US DEPARTMENT OF ENERGY
HANFORD WASTE VITRIFICATION PLANT

DESIGN CHANGE NOTICE

DCN - 0100 | REV 1 | PAGE 1 OF 18

DCN TITLE: THIS DCN-0100 SUPERSEDES "DCN-0096" & "DCN-0096 REV 1"

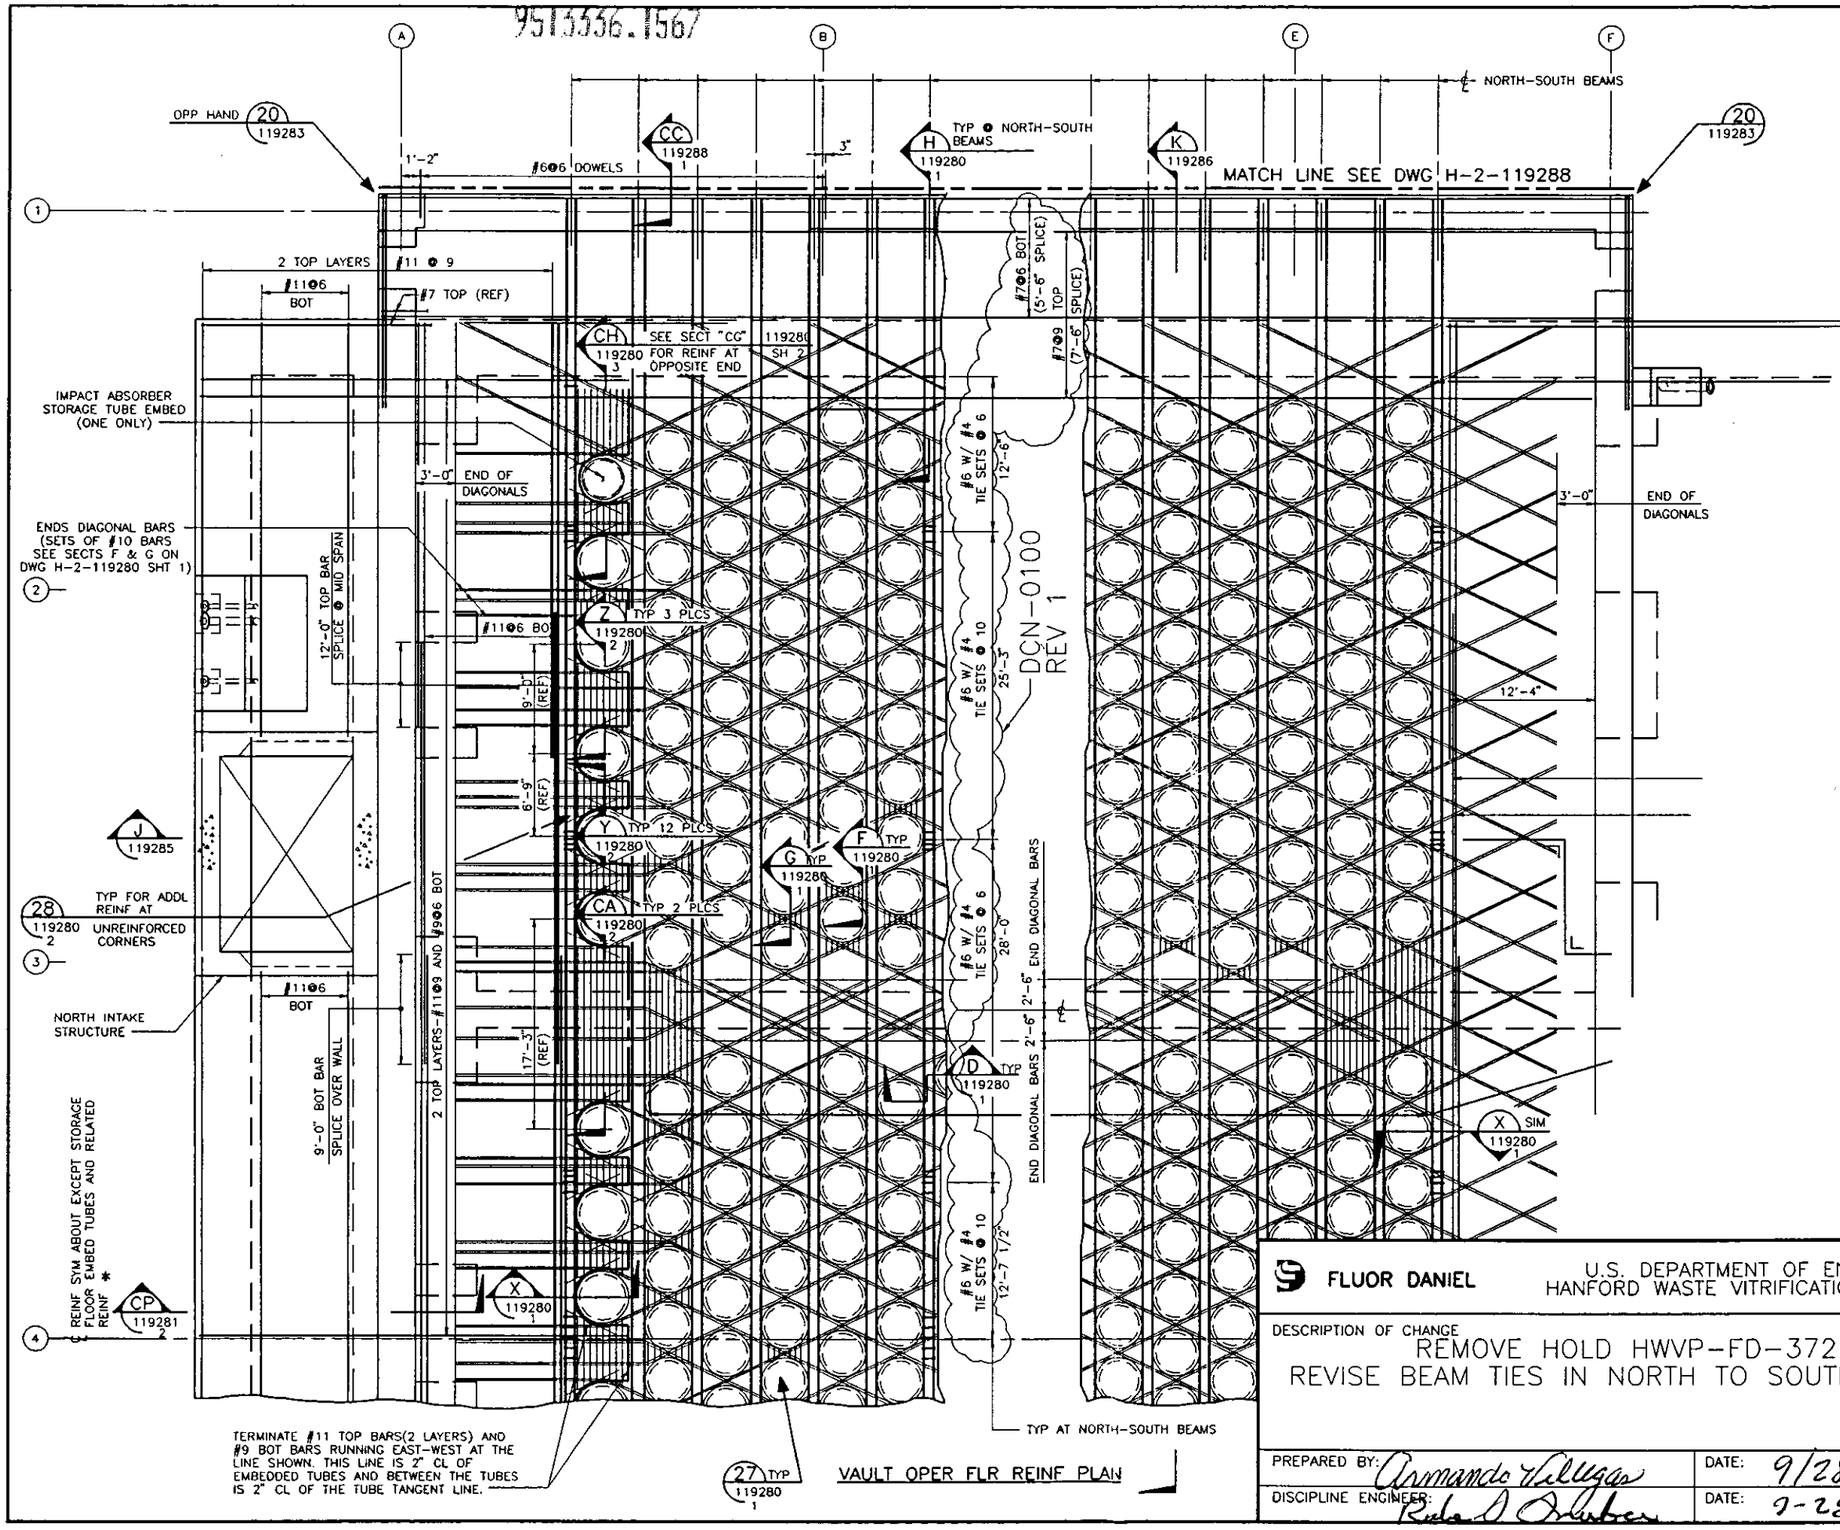
FLUOR DANIEL	U.S. DEPARTMENT OF ENERGY HANFORD WASTE VITRIFICATION PLANT	DESIGN CHANGE NOTICE
DESCRIPTION OF CHANGE REMOVE HOLD HWVP-FD-372. REVISE BEAM TIES IN NORTH TO SOUTH BEAMS.		BASE DOC. NO. H-2-119279 SHT/PG. 1 REV. 1 CR NO. CR-HWVP-1025 DISCIPLINE: STRUCTURAL/DCN0096M
PREPARED BY: Armando Villegas	DATE: 9/28/93	DCN - 0100 REV. 1 PAGE 6
DISCIPLINE ENGINEER: Richard Schuber	DATE: 9-28-93

SECTION D 119279

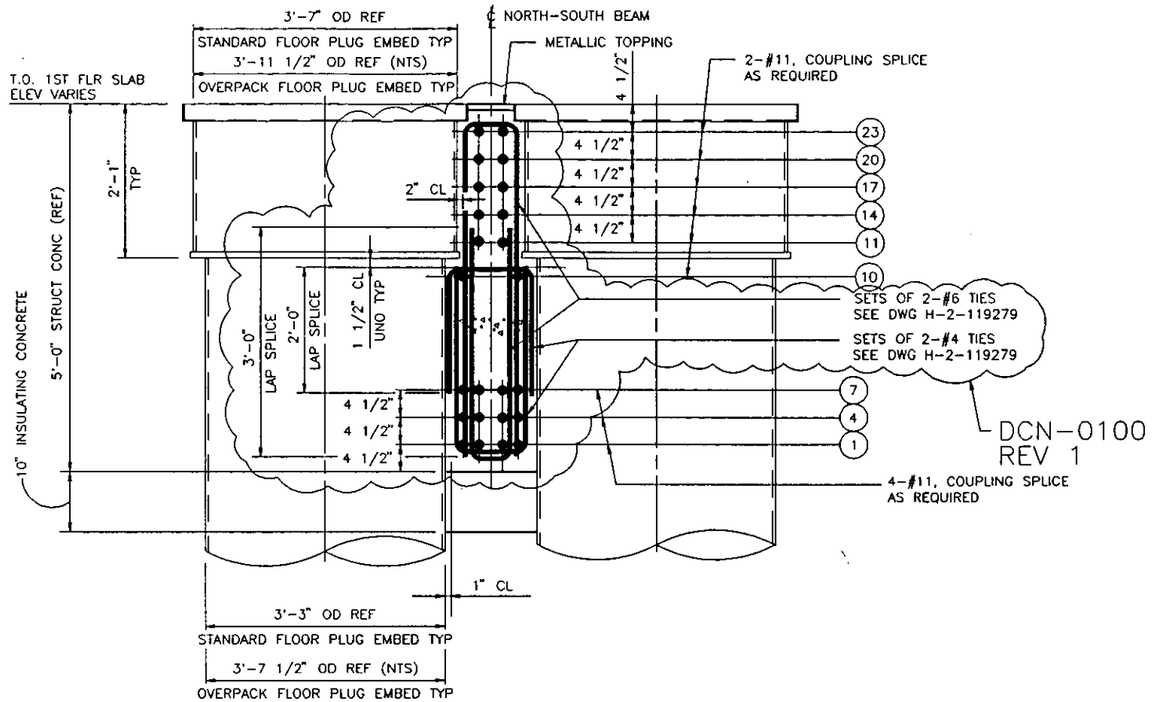
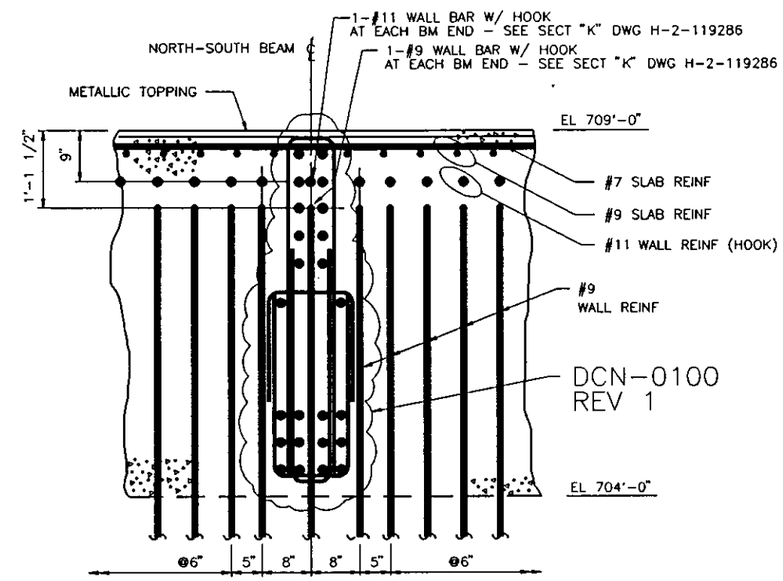
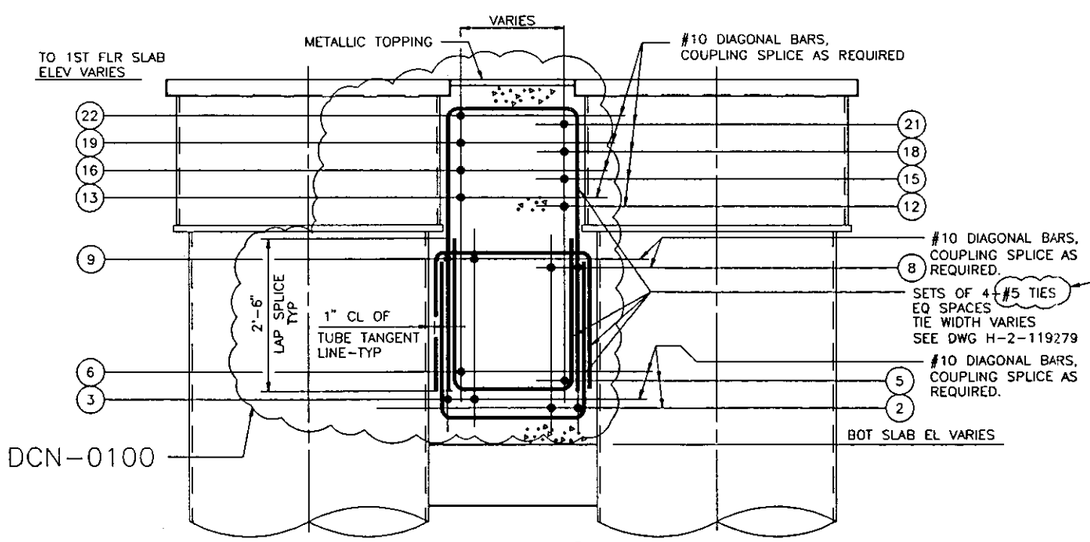
FLUOR DANIEL — U.S. DEPARTMENT OF ENERGY, HANFORD WASTE VITRIFICATION PLANT		DESIGN CHANGE NOTICE
DESCRIPTION OF CHANGE: REMOVE HOLD HWVP-FD-372. REVISE REINFORCING TIES.		BASE DOC. NO. H-2-119280; SHT/PG. 1; REV. 1; CR NO. CR-HWVP-1025; DISCIPLINE: STRUCTURAL/DCN0096N
PREPARED BY: Armando Villegas	DATE: 9/28/93	DCN - 0100 — REV. 1 — PAGE 7
DISCIPLINE ENGINEER: Robert J. Amber	DATE: 9-28-93

DETAIL 27
119279

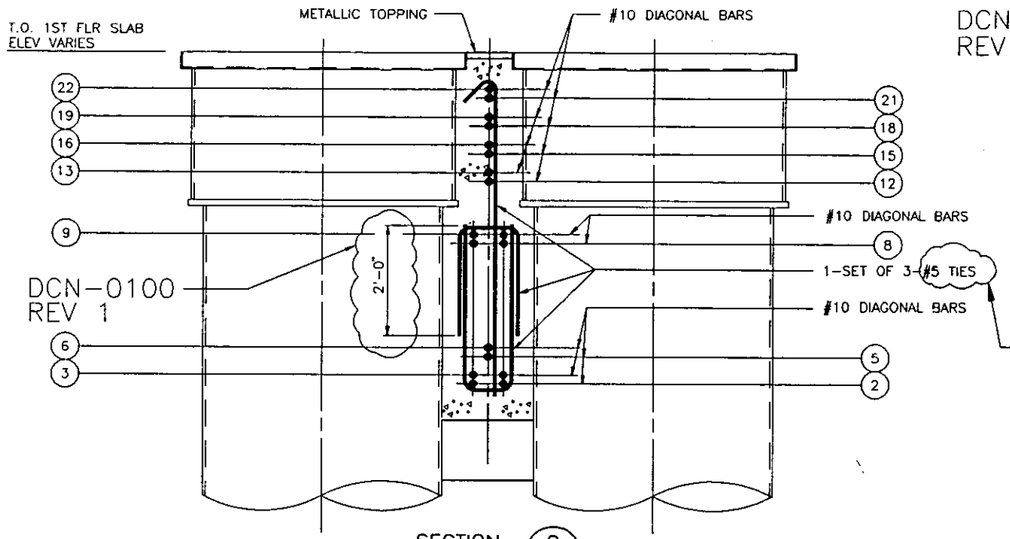
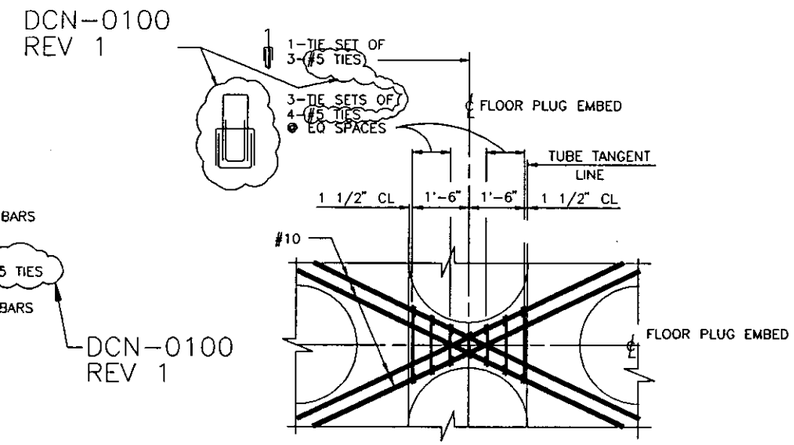
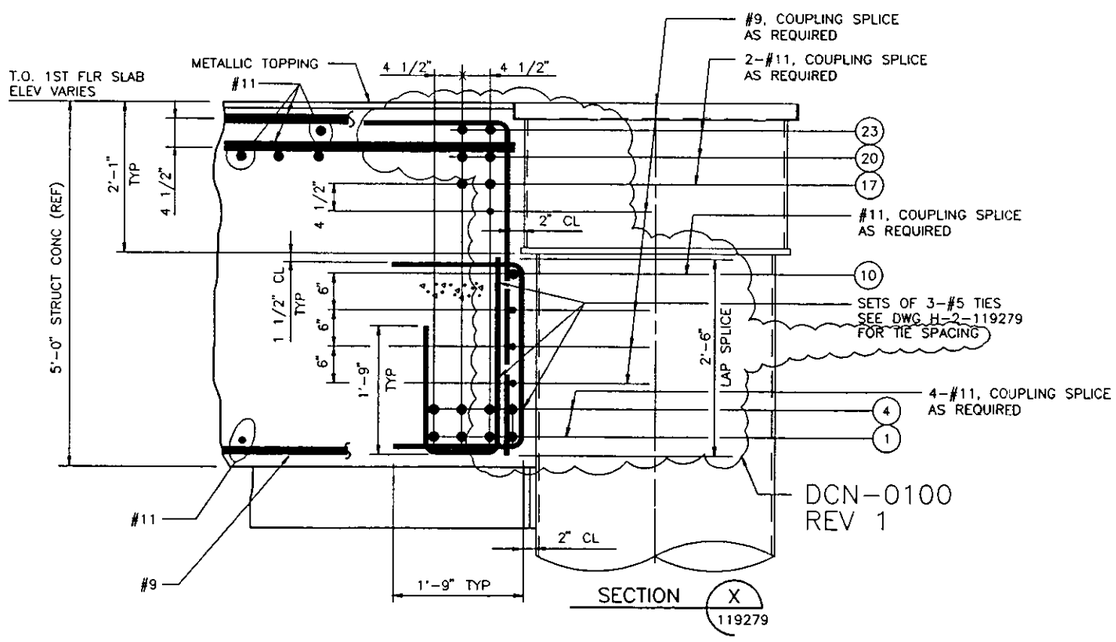
FLUOR DANIEL — U.S. DEPARTMENT OF ENERGY, HANFORD WASTE VITRIFICATION PLANT		DESIGN CHANGE NOTICE
DESCRIPTION OF CHANGE: REMOVE HOLD HWVP-FD-372. REVISE REINFORCING TIES.		BASE DOC. NO. H-2-119280; SHT/PG. 1; REV. 1; CR NO. CR-HWVP-1025; DISCIPLINE: STRUCTURAL/DCN00960
PREPARED BY: Armando Villegas	DATE: 9/28/93	DCN - 0100
DISCIPLINE ENGINEER: Rob Dreuber	DATE: 9-28-93	REV. 1; PAGE 8

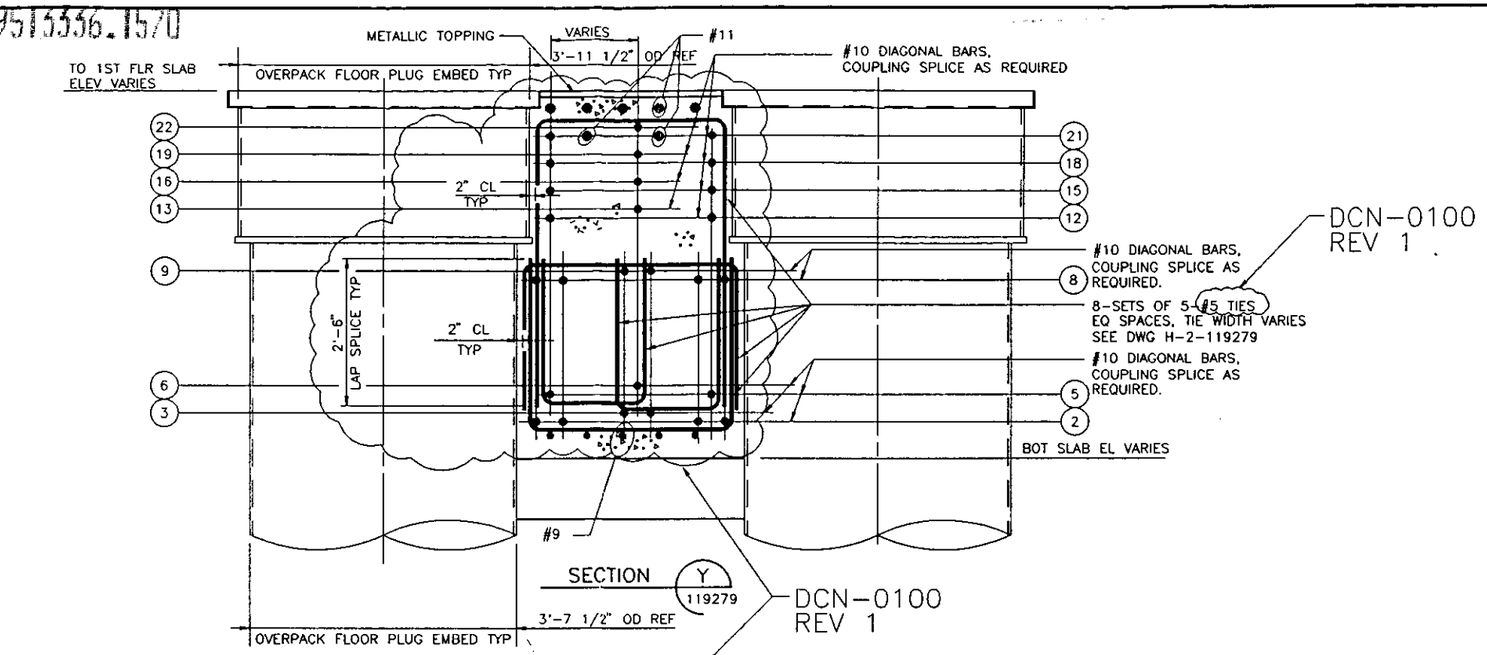
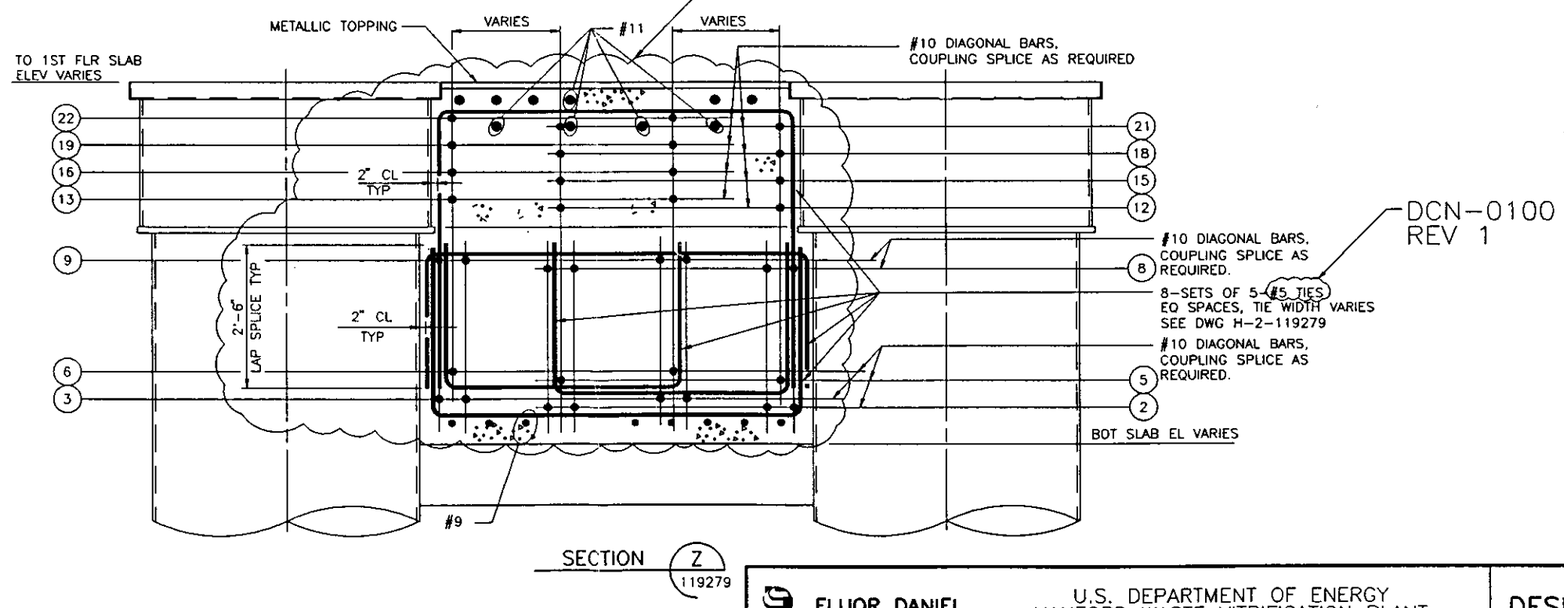
FLUOR DANIEL	U.S. DEPARTMENT OF ENERGY HANFORD WASTE VITRIFICATION PLANT	DESIGN CHANGE NOTICE
DESCRIPTION OF CHANGE REMOVE HOLD HWVP-FD-372. REVISE REINFORCING TIES.		BASE DOC. NO. H-2-119280 SHT/PG. 2 REV. 1 CR NO. CR-HWVP-1025 DISCIPLINE: STRUCTURAL/DCN0096P
PREPARED BY: Armando Villegas	DATE: 9/28/93	DCN - 0100 / REV. 1 / PAGE 9
DISCIPLINE ENGINEER: Robert J. Jaubert	DATE: 9-28-93

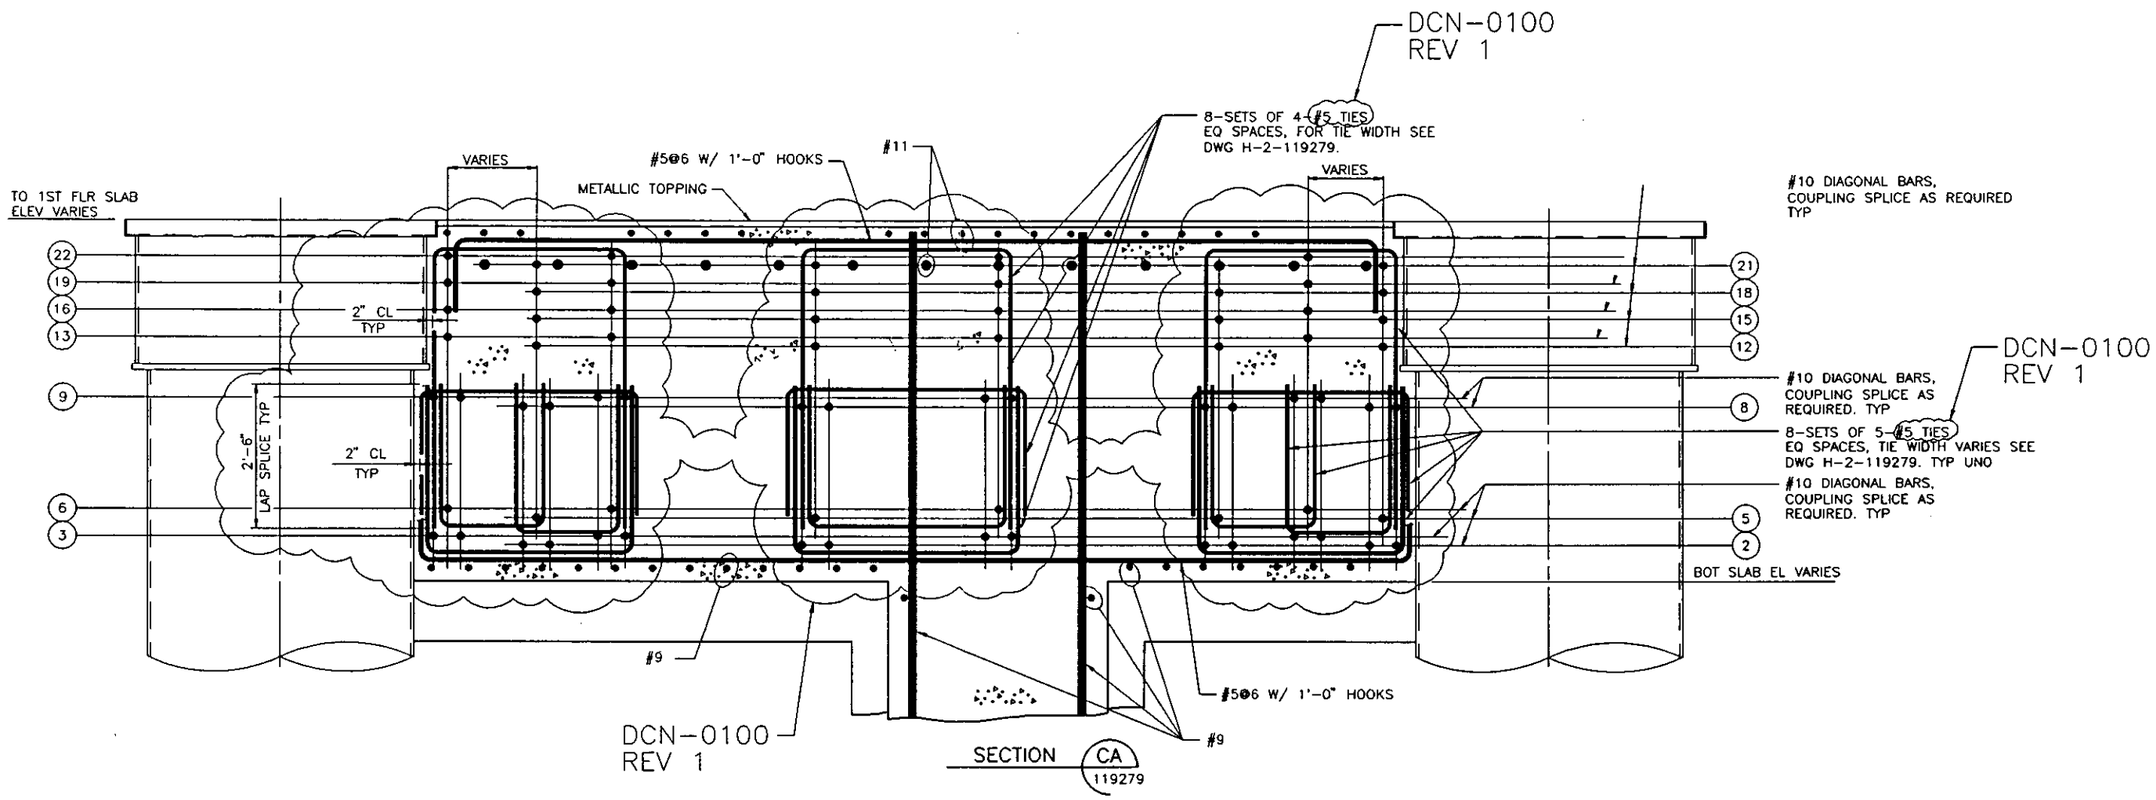
FLUOR DANIEL	U.S. DEPARTMENT OF ENERGY HANFORD WASTE VITRIFICATION PLANT	DESIGN CHANGE NOTICE
DESCRIPTION OF CHANGE REMOVE HOLD HWVP-FD-372. REVISE REINFORCING TIES.		BASE DOC. NO. H-2-119280 SHT/PG. 2 REV. 1 CR NO. CR-HWVP-1025 DISCIPLINE: STRUCTURAL/DCN0096Q
PREPARED BY: Armando Villegas	DATE: 9/28/93	DCN - 0100 / REV. 1 / PAGE 10
DISCIPLINE ENGINEER: Robert J. Gruber	DATE: 9-28-93
